Determination 2008/24

Refusal to issue a code compliance certificate for a new house due to a dispute over compliance of jamb flashing at 213 Minden Road, RD6, Tauranga

Figure 1: Installation detail showing the aluminium scribe (taken from the manufacturer's literature)

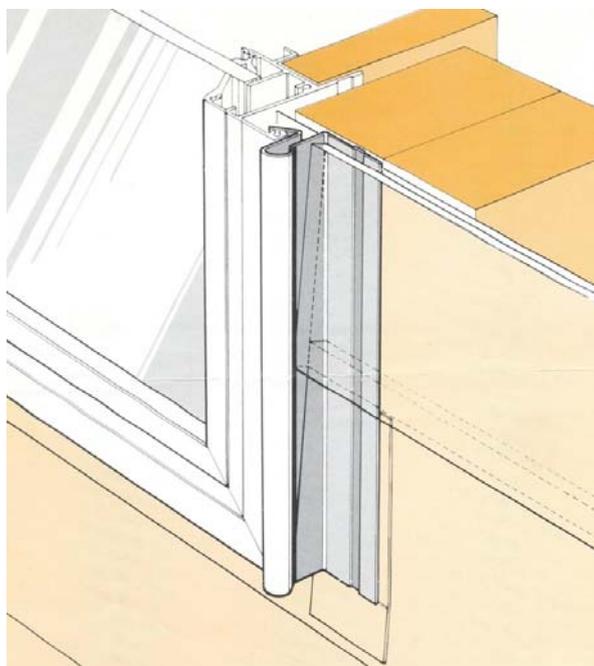
- the scribes are installed generally in accordance with the manufacturer's instructions
 - there is an adequate seal between the top of the scribe and the head flashing

- the weatherboards are sealed to the scribes
 - there is free drainage at the lower ends of the scribes and at the ends of lower weatherboards where they met the scribe (after the builder on site cleared small drainage channels)

- the plastic apron flashing installed between the scribes and the weatherboards is an appropriate and effective water deflection and drainage element. However the apron is sealed where it is "sandwiched" at its junction between the adjoining weatherboards

- as the scribe is "tucked in" behind the jamb, extends behind the weatherboards, and provides an effective drainage path, it is comparable to, and in some respects superior to the scribe profile shown in figure 42 of the Linea weatherboard manufacturer's recommendations.

- 5.7 In summary, the expert considered that in this particular case the "aluminium jamb flashings used are at least equal to the timber scribe scheme system outlined in Linear (*sic*) manual and in E2/AS1 for timber weatherboards". In the opinion of the expert, the installed system is superior as regards:

- 6.3.4 The territorial authority believed that there was an issue regarding the compression of the scribe but accepted that the provision of a cavity was an additional safeguard if moisture penetrated the cladding. If it was certain that the scribe channels released water, then the territorial authority could accept that the jamb detail would comply with clauses B2 and E2.

- 10.1 In accordance with section 188 of the Building Act 2004, I determine that the building work complies with Clauses B2 and E2 of the Building Code, and accordingly reverse the territorial authority's decision to refuse to issue a code compliance certificate.
